Project	IEEE 802.16 Broadband Wireless Access Working Group <http://ieee802.org/16>		
Title	Modified TEK State Machine for the MBRA (Multicast & Broadcast Rekeying Algorithm)		
Data Submitted	2004-11-15		
Source(s)	Seokheon Cho Sungcheol Chang Chulsik Yoon,	ETRI	Voice: +82-42-860-5524 Fax: +82-42-861-1966 chosh@etri.re.kr
	161, Gajeong-dong, Yuseong-Gu, Daejeon, 305-350, Korea

Modified TEK State Machine for the MBRA

[Change section 7.2.5 as described below:]

Figure 132a-TEK state machine flow diagram

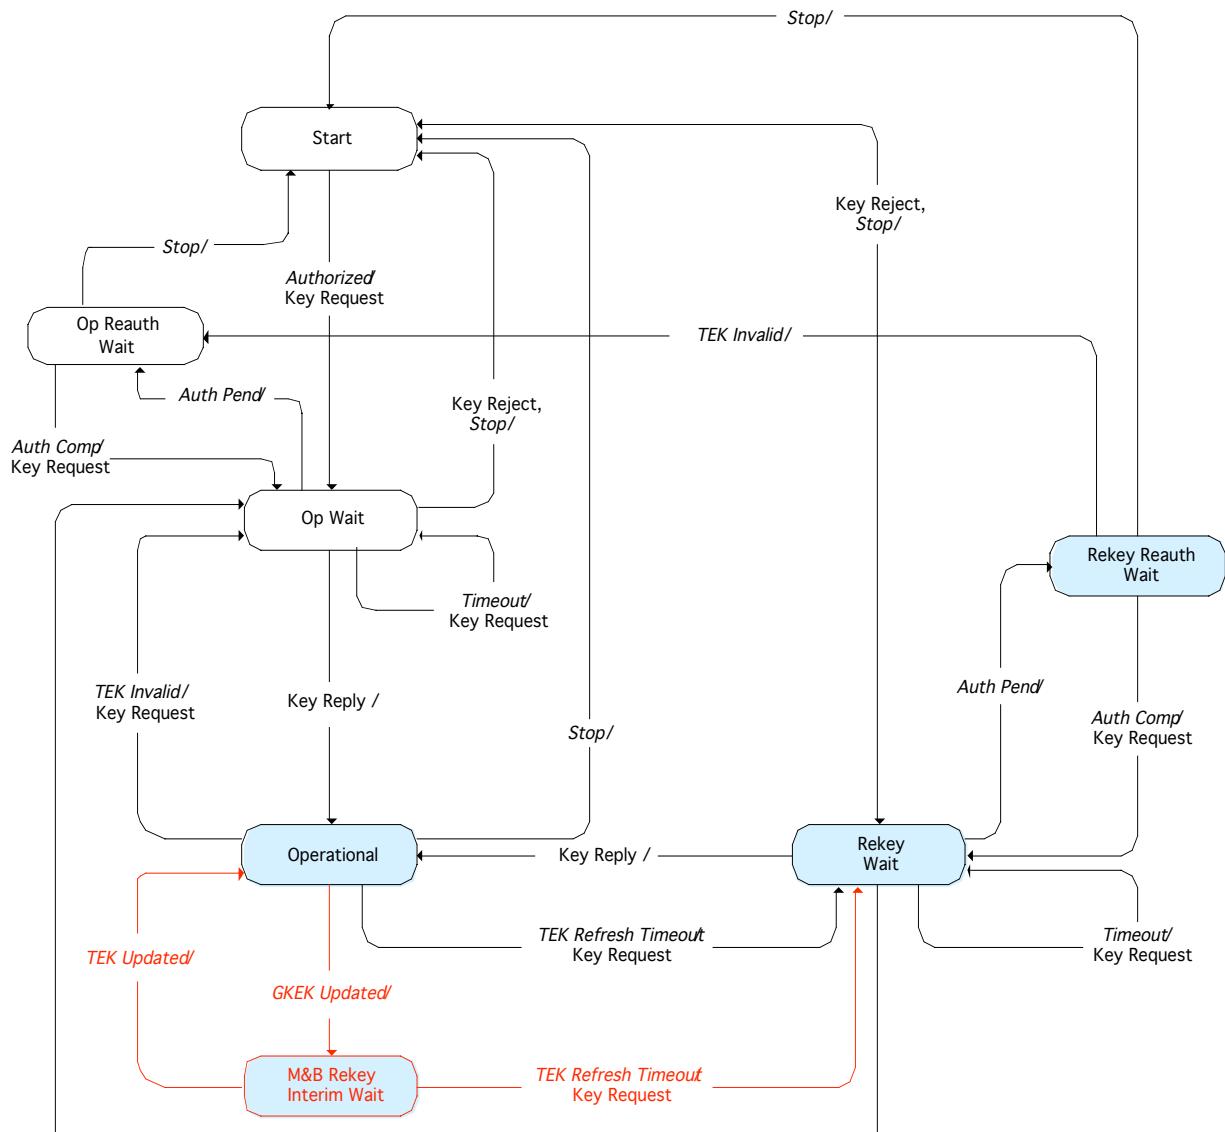
The TEK state machine consists of ~~six~~ seven states and ~~nine~~ eleven events (including receipt of messages) that can trigger state transitions. Like the Authorization state machine, the TEK state machine is presented in both a state flow diagram (Figure 132a) and a state transition matrix (Table 132a). As was the case for the Authorization state machine, the state transition matrix shall be used as the definitive specification of protocol actions associated with each state transition.

Shaded states in Figure 132 (Operational, Rekey Wait, ~~and Rekey Reauthorize Wait~~ Rekey Reauthorize Wait, and M&B Rekey Interim Wait) have valid keying material and encrypted traffic can be passed.

M&B Rekey Interim Wait (Multicast & Broadcast Rekey Interim Wait): This state is defined only for the multicast service or the broadcast service. This state is the wait state the TEK state machine is placed in if the TEK state machine has valid traffic keying material and receives the new GKEK from the BS.

7-G M&B Rekey Interim Wait (*TEK Refresh Timeout*) -> Rekey Wait

10-D Operational (*GKEK Updated*) -> M&B Rekey Interim Wait

11-G M&B Rekey Interim Wait (*GTEK Updated*) -> Operational

- a) send Key Request message to BS
- b) set Key Request retry timer to Rekey Wait Timeout

- a) process contents of Key Update Command message for the GKEK update mode and incorporate new GKEK into key database

- a) clear Key Request retry timer
- b) process contents of Key Update Command message for the GTEK update mode and incorporate new traffic keying material into key database
- c) set the TEK refresh timer to go off “TEK Grace Time” seconds prior to the key’s scheduled expiration
